Product Change Notification

Bourns® Model SRP4012 and SRP4020 Series Shielded Power Inductors

Change to Packaging Specifications

Current Packaging Carrier Tape Specifications

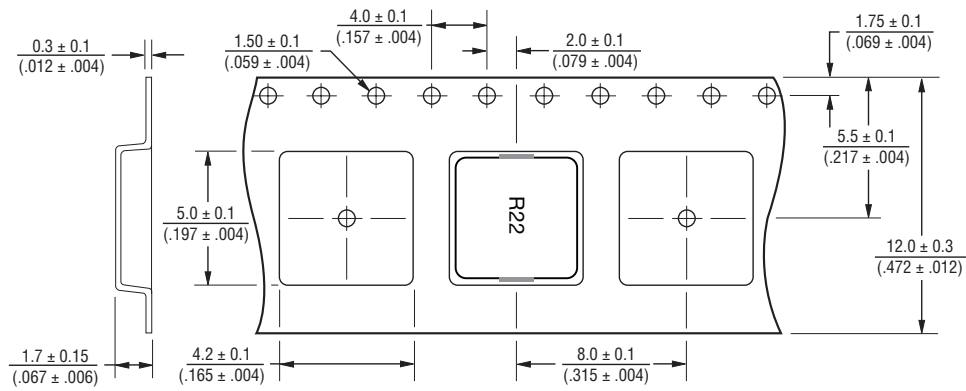
Effective immediately, Bourns is changing the inductor packaging carrier tape specifications for the [Model SRP4012](#) and [SRP4020 Series](#) Shielded Power Inductors due to the obsolescence of the current carrier tape design. The current and revised specifications of the carrier tape are provided on the following pages. The form, fit, function, quality and reliability of the inductor will remain the same.
